Westinghouse Electric Company LLC  
Hematite Decommissioning Project  
3300 State Road P  
Festus, MO 63028  
USA

Subject: Draft Supplemental Response to NRC Request for Additional Information on the  
Hematite Decommissioning Plan Excluding Chapter 11 (License No. SNM-  
00033, Docket No. 070-00036)

References 1 to 11 provided Westinghouse responses to NRC's Requests for Additional Information (RAIs) concerning the Hematite Decommissioning Plan (DP). This letter provides draft supplemental responses to those RAIs where NRC required clarification. These draft supplemental responses are provided in support of the scheduled June 24 and 27 conference calls identified in Reference 12.

Figure 3. Bedrock Topography in the Vicinity of the Hematite Site  
(z-axis is ft above mean sea level, x-axis and y-axis are standard easting and northing grids)

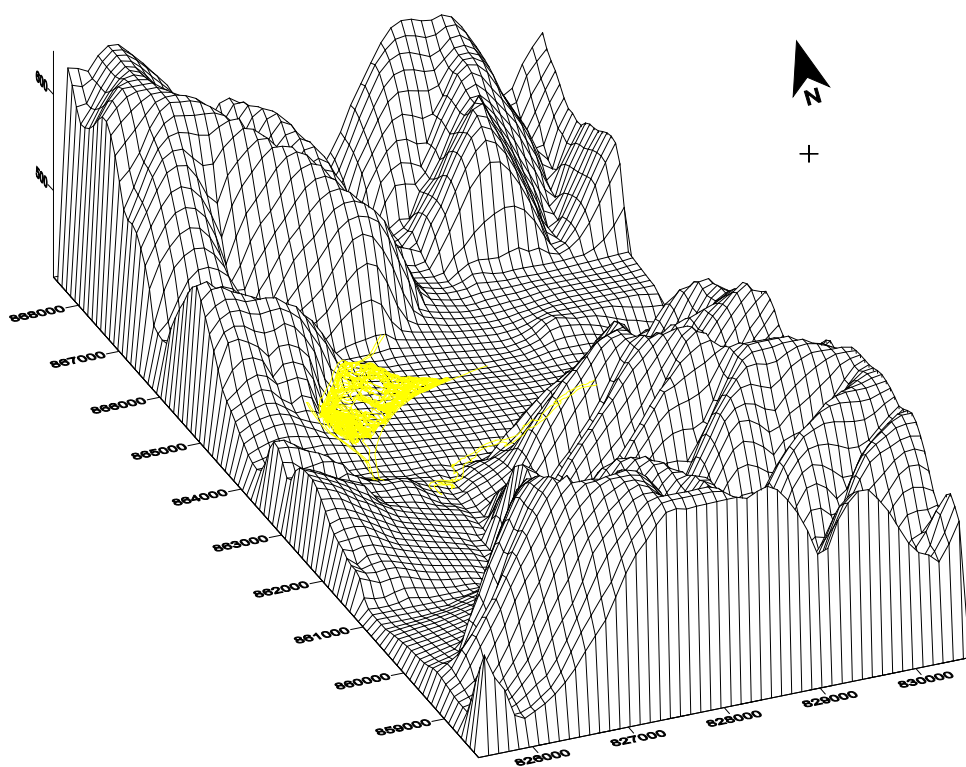
3-7	(c) “...The increasing height of the bedrock to the north and northwest would preclude general flow direction of north or northwest”.	<p>Need to discuss the basis for this conclusion.</p> <p>The hydraulic heads measured from monitoring wells appear to indicate a possibility that groundwater in the Jefferson-Cotter HSU may locally flow towards north/northwest direction at the NW site boundary area of site buildings. The Discussion Points provided address the flow in general terms. Are there site or local specific conditions that show otherwise?</p>	<p>The Jefferson City-Cotter HSU is a component of the Ozark aquifer on the Salem Plateau. Imes and Emmett (1994) and Miller and Vandike (1997) indicate that groundwater within the Ozark aquifer [which contains the Cotter, Jefferson City and Roubidoux Formations] occurs under unconfined conditions with groundwater flow occurring from upland areas toward valleys where it discharges as stream base flow. In the vicinity of the Hematite Site, groundwater within the Jefferson City – Cotter HSU appears to be unconfined. However, the results of a variety of hydraulic testing and potentiometric measurements for the Roubidoux HSU suggest that the deeper aquifer is confined. (Source: “Radionuclide Activity in Bedrock Groundwater at Westinghouse Hematite Facility, Hematite, Missouri,” which was provided to NRC via Westinghouse letter HEM-09-133, dated 11/10/2009.)</p> <p>The Hematite facility is located in the Joachim Creek valley with groundwater flow occurring from bedrock formations comprising the valley sides and moving toward Joachim Creek. The facility and Joachim Creek are shown in yellow in the attached Figure 3. This figure is intended to show the relative steepness of the valley within which the facility is located. The local site specific conditions of hills to the northwest of the site and the gaining Joachim Creek to the southeast of the site suggest that the upper bedrock layer (Jefferson City-Cotter) slopes towards the southeast, with groundwater flowing in that direction. As seen in the groundwater flow maps provided in the response to RAI 4-13, the water level data at PZ-04 only intermittently appears to “mound,” and create an appearance of flow to the northwest. This “mounding” is considered an anomaly, attributed to local natural geologic and hydrogeologic conditions possibly resulting from a combination of locally confined conditions, a local lack of secondary porosity features such as fractures or joints, and massive, fine-grained bedrock lithology in the screened interval in each well.</p> <p>Imes, J.L. and Emmett, L.F. 1994. <i>Geohydrology of the Ozarks Plateau Aquifer System in Parts of Missouri, Arkansas, Oklahoma, and Kansas</i>, U.S. Geological Survey Professional Paper 1414-D, Regional Aquifer System Analysis- Central Midwest. pp 43-51.</p> <p>Miller, D.E. and Vandike, J.E. 1997. <i>Groundwater Resources of Missouri</i>, Missouri State Water Plan Series Volume II, Missouri Water Resources Report No 46, Missouri Department of Natural Resources, Rolla, Missouri. pg 64.</p>	Westinghouse has provided the requested clarifying information in the Discussion Points. No further action required.

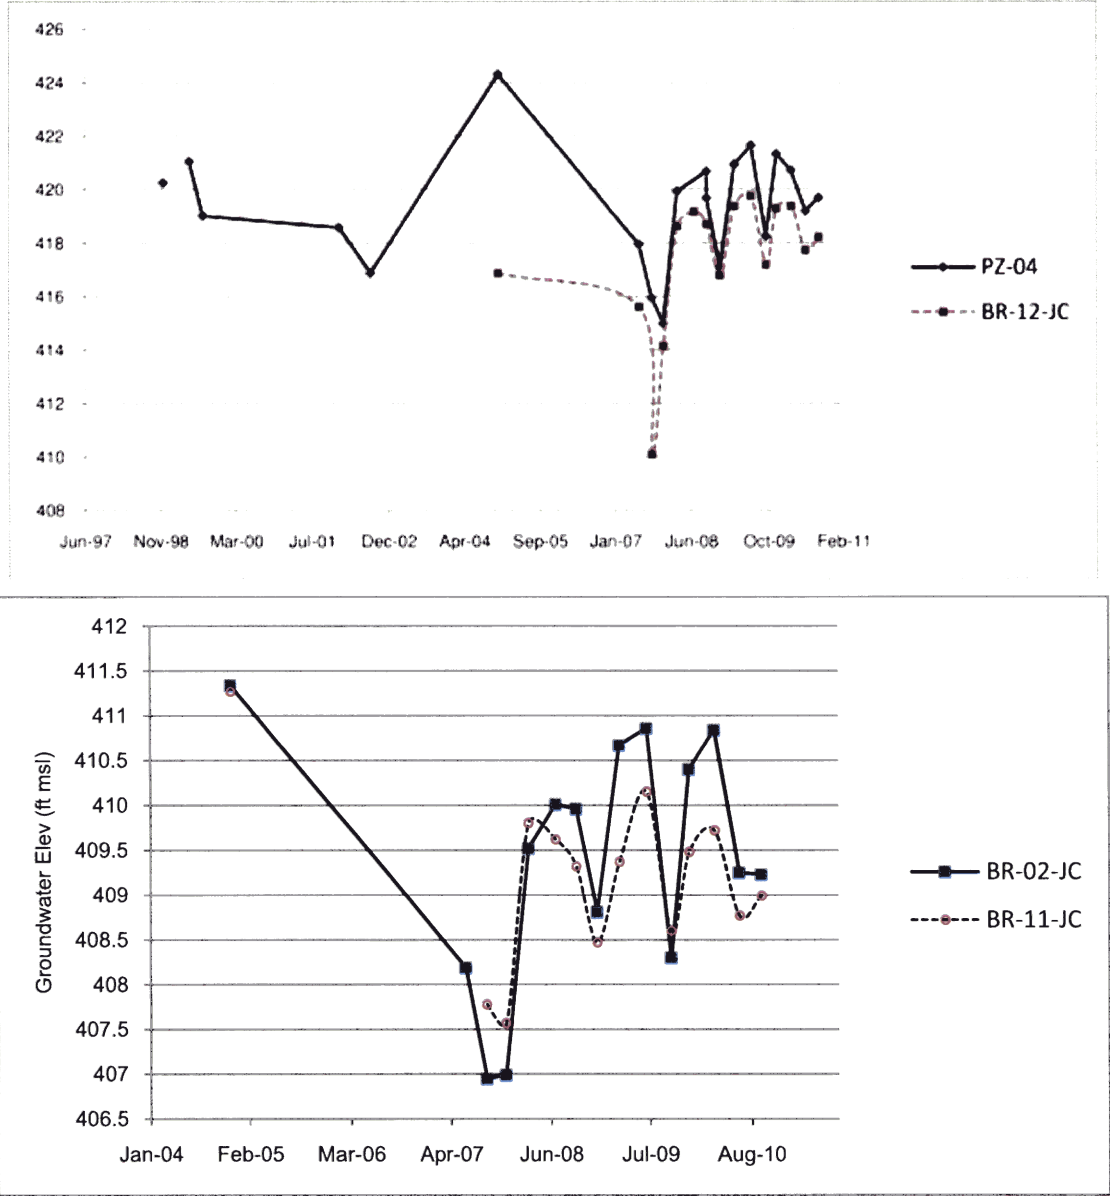
4-8b	Tc-99 in GW-X/PL-06	Provide the basis for Westinghouse's claim that the Tc-99 in GW-X/PL-06 is due to the thickness of the sand at this location and that seasonal variation can cause the sand to be unsaturated and allow water containing Tc-99 in the overlaying clay to drain into the sand/gravel zone. Justify the basis when similar concentrations of Tc-99 found in both sand/gravel and hybrid wells seem	Summary: These wells are located in an area with unique subsurface sand characteristics. Sand was observed extending about 10 feet above the sand/gravel layer into a sandy clay layer. This sandy clay layer is suspected to provide lateral transport not seen in the regular silty clay soil identified at the rest of the Site. The screens for both wells GW-X/PL-06 extend into the sandy clay layer. A former leach field and the sewage treatment line (if it leaks) are potential sources of contamination in the area; these areas are planned for remediation. The soil around these wells will be sampled in the same manner as the wells under the former Process Buildings, as specified in Westinghouse letter HEM-11-56, dated May 5, 2011. Also, as specified in that letter, soil sample results exceeding the DCGL require further investigation as to the extent of contamination, remediation, and final status	Westinghouse has provided the requested clarifying information in the Discussion Points. No further action required.

RAI No.	Issues	Path Forward	Discussion Points	Proposed Resolution																																																																																																												
		<p>to indicate that the contamination in the sand/gravel aquifer may not be resulted from the transport of “leachate” through a hybrid well. Provide the basis for the claim when it appears that there is no known contaminated soil in the immediate vicinity of this well couple.</p> <p>The Tc-99 detected in the sand/gravel at GW-X may not result from the installation of hybrid well PL-6. As GW-X is approximately 10 ft upgradient of PL-6, an overlapping of wells screens in both wells should not cause Tc-99 contamination in the sand/gravel by transporting contaminated “leachate” in the overburden clay/sandy clay above. Potential sources cited include former leach field, leak from a sewage treatment line, and also potentially preferential flow path along the gas line passing through the evaporation ponds. Why is there a significant concentration of Tc-99 at this well?</p>	<p>surveys for compliance.</p> <p>Discussion: The well pair GW-X/PL-06 is located along the southern perimeter of the facility, immediately south of Building 231. Groundwater monitoring in hybrid Well PL-06 between 2004 and 2011 indicates that the sand thickness encountered at the bottom of the well is routinely saturated as shown in the table below. However, unlike other site monitoring wells, there is also a sandy clay layer that is unsaturated and would provide greater lateral migration than silty clay. Since the screen for Well PL-06 extends into the sandy clay layer, the water in the sandy clay layer may move laterally to ‘drain’ from the sandy clay layer into the sandy gravel layer.</p>

## Core Data

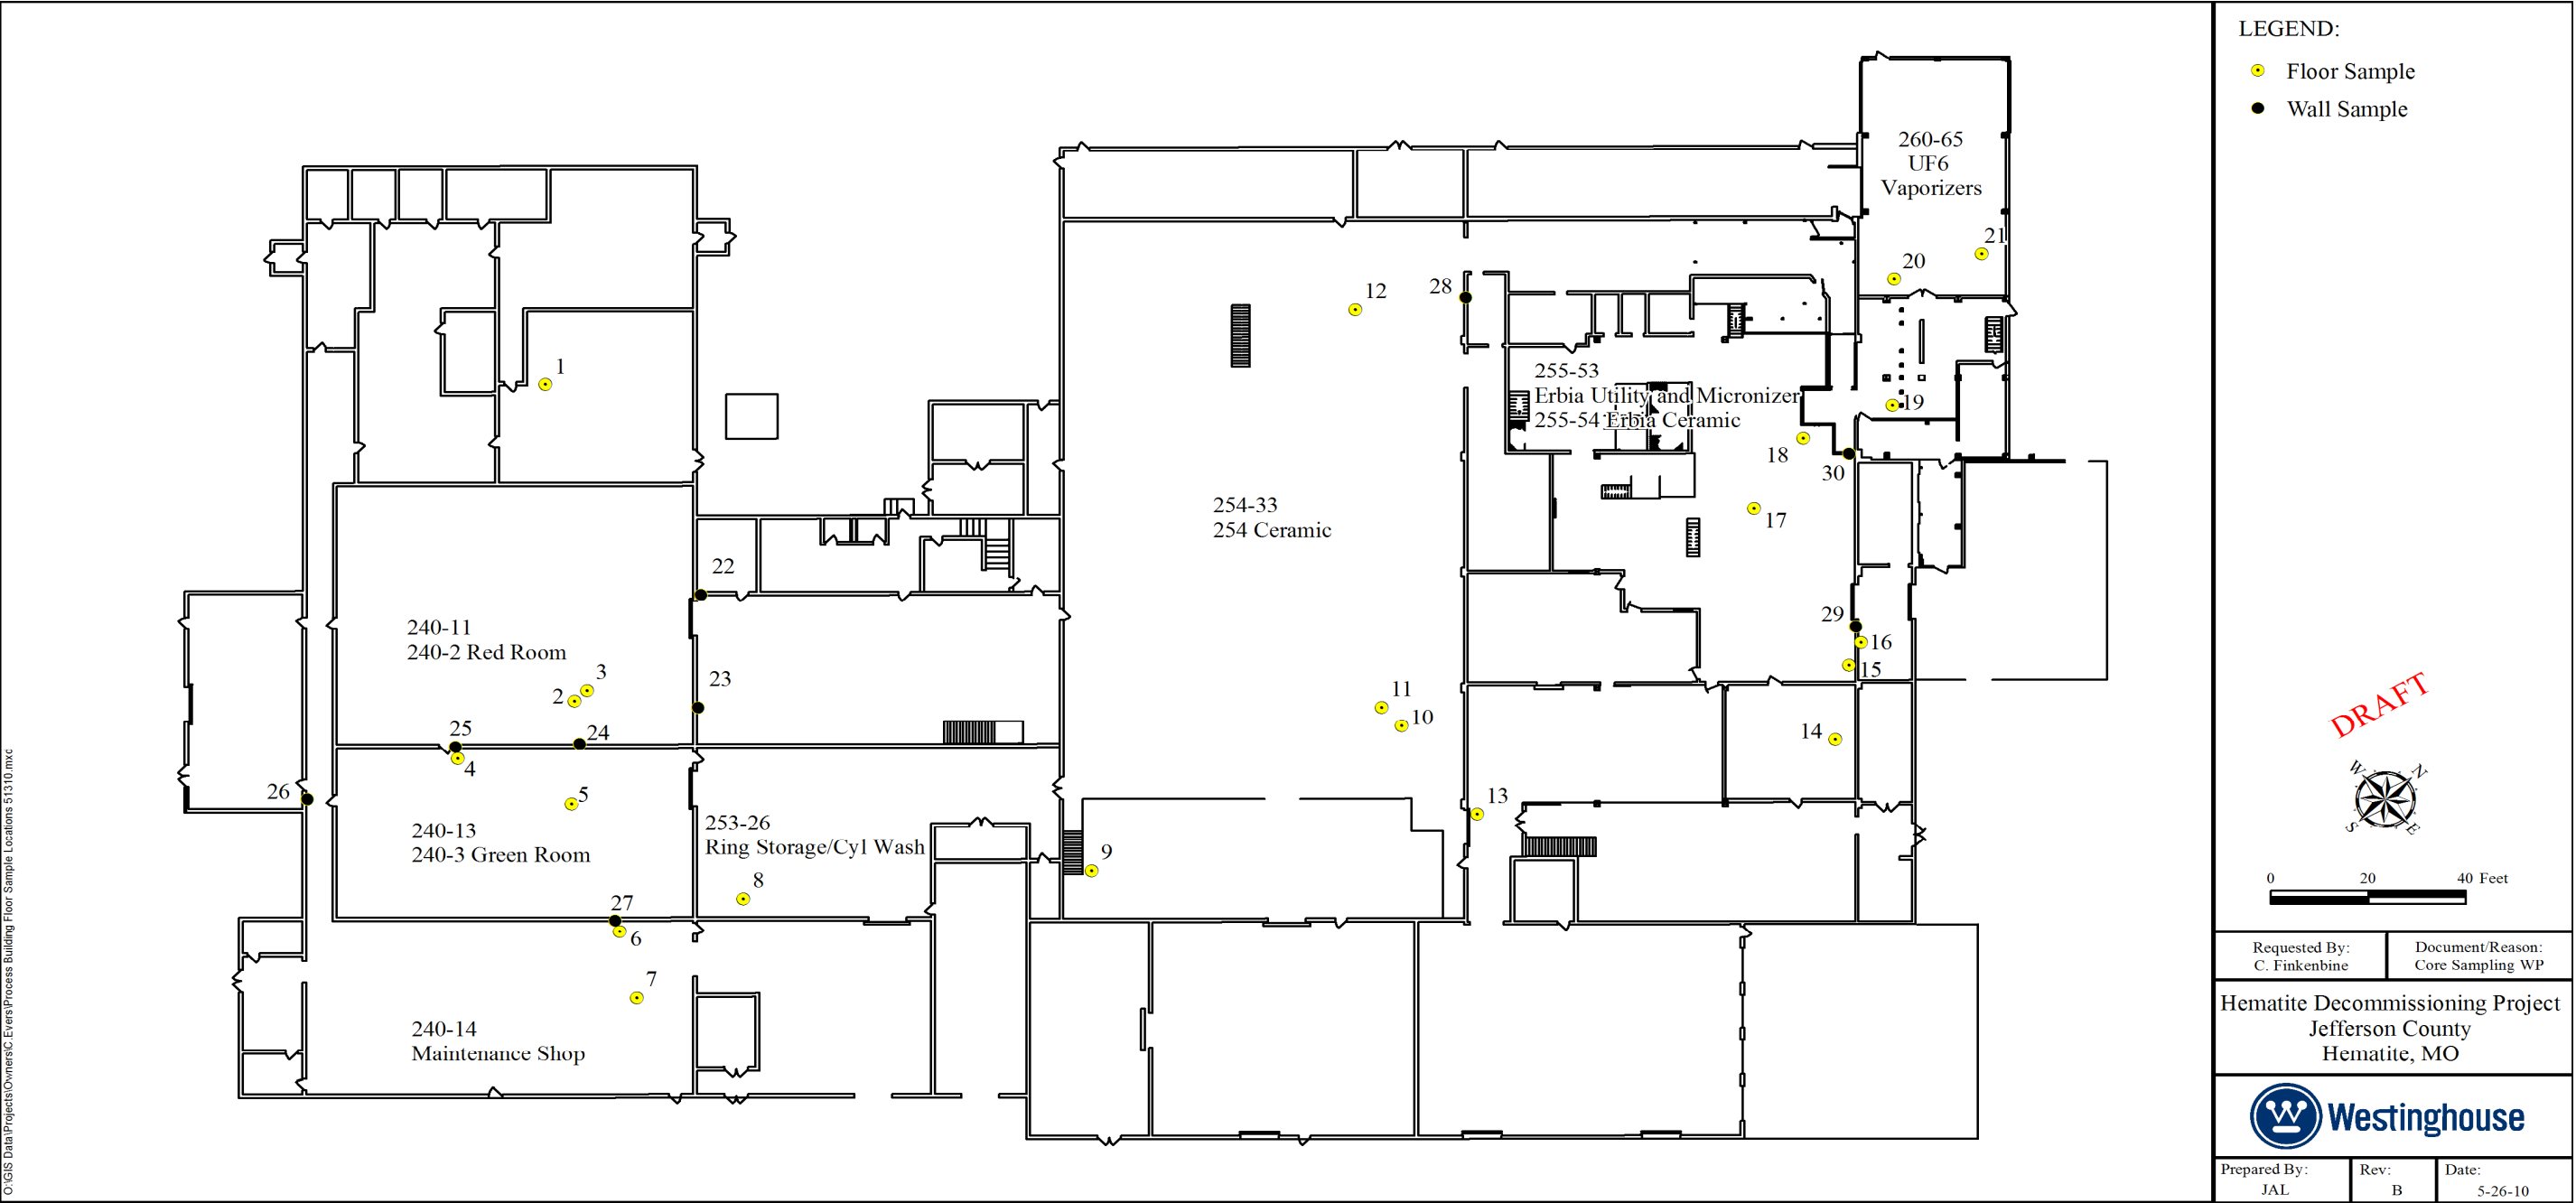
RAI No.	Issues	Path Forward	Discussion Points	Proposed Resolution
4-6a	2010 concrete core data samples	<p>(1) Clarify if the concrete core samples taken by WEC in 2010 from the buildings were analyzed for contamination and</p> <p>(2) How the results will be included in the DP.</p> <p>(3) Clarify if these samples taken for the concrete and soil were biased towards cracks and crevices.</p> <p>Clarification on whether the NRC received the results of these samples. Staff questions Westinghouse's position that the data is not necessarily applicable to the DP. While the material that was characterized is likely going to be sent off site, it would seem that this data is still relative for the DP because it provides information on the relative ratios of radionuclides in the buildings.</p> <p>The ratios observed in the concrete cores are mostly consistent with the ratios assumed in the DP for the buildings that will remain after decommissioning. The exception to this is that some of the samples from stations 2, 3, 20, and 21 have high Tc results. What was the source of this Tc? Is it known from process history that the cause of the Tc contamination in the demolished buildings is also the cause in the buildings that will remain? In other words, how does Westinghouse know that they do not have any similar areas of Tc contamination in the buildings that are going to remain.</p>	<p>(1) The concrete core samples taken in 2010 from the floor of the former Process Buildings were analyzed by an off-site laboratory. The samples from each sample location was analyzed by gamma spectroscopy for K-40, Bi-212, Pb-212, Bi-214, Pb-214, Ac-228, Pa-231, Th-232, Pa-234, Th-234, U-235 and isotopic uranium. Additionally, all samples were analyzed for Tc-99 by liquid scintillation. A minimum MDC of 1 pCi/g was targeted for this analysis. The sample results represented the top-most ¼ inch, the subsequent ¼ - ¾ inch in depth, the balance of the concrete core, and the underlying soil-like material.</p> <p>(2) The data was collected for waste characterization purposes, and was not intended to be included in the DP. However, the data will be included in a request for disposal under the provisions of 10 CFR 20.2002 that will be submitted to the NRC within the next few months.</p> <p>(3) These locations for concrete and soil sampling were biased towards cracks and crevices.</p> <p>(4) The core sampling data are provided in a separate spreadsheet following this matrix. In 2010, Characterization of Former Process Buildings Slabs involved coring of the concrete floors was performed to more extensively characterizes the depth of penetration and radionuclide contamination in concrete. Core samples were biased toward locations with high surface activity (as determined by NaI measurements) and where cracks were evident within the floor surface. After removing the concrete cores, Westinghouse obtained samples of the immediately underlying soil/gravel fill. These sampling locations are shown on Figure 1 of the paper "Evaluation of Technetium-99 Under the Process Buildings" with identification numbers from 1 to 21.</p> <p>(5) Sample stations 2, 3, 20 and 21 were located in the concrete floor of the Process Buildings. These sample stations, which have elevated Tc-99, were located where wet processes associated with fuel fabrication were used. The wet processes provided the mechanism for Tc-99 contamination of the concrete. Wet processes were not used in the buildings that are going to remain.</p>	Westinghouse has provided the requested clarifying information in the Discussion Points. No further action required.
